Simultaneous Transmit and Receive (STR) Relaying

Document Number: **S802.16m-10/0202**

Re: **IEEE 802.16-10/0011, IEEE 802.16 Working Group Letter Ballot Recirc #31 / Topic: Relay Format (Section 16.6.1)**

Purpose: **To be discussed and adopted by TGm for P802.16m/D5**

Proposed AWD Text Modification

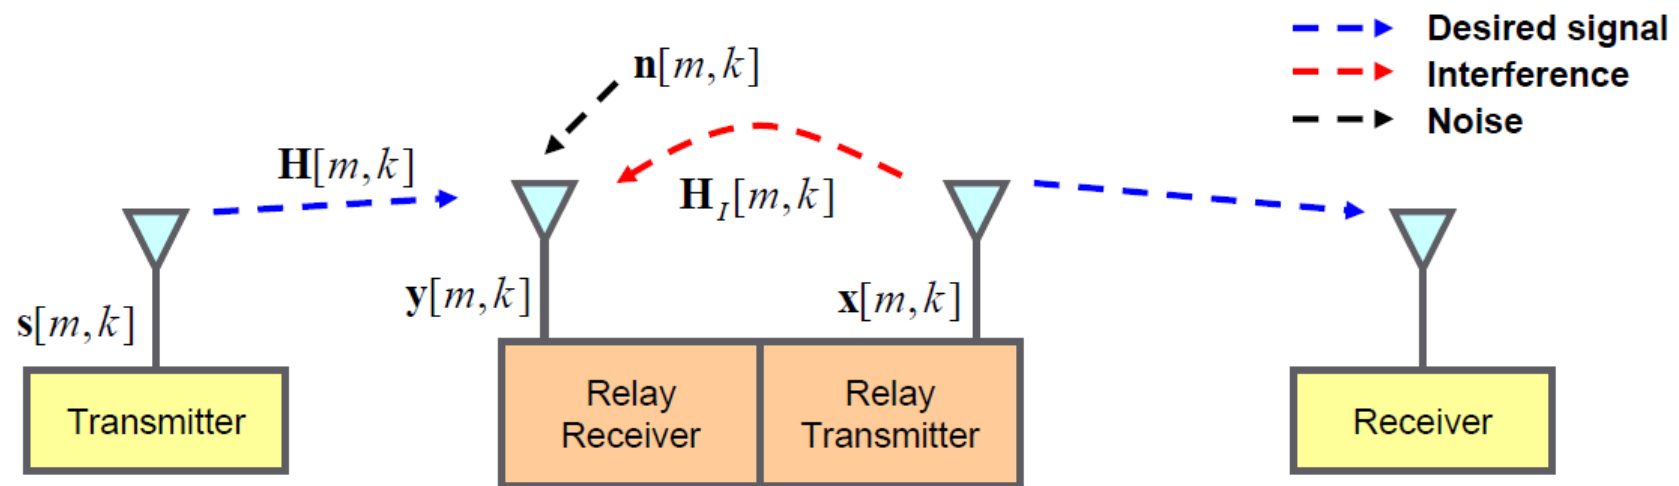
- Refer to IEEE C802.16m-10/0202.
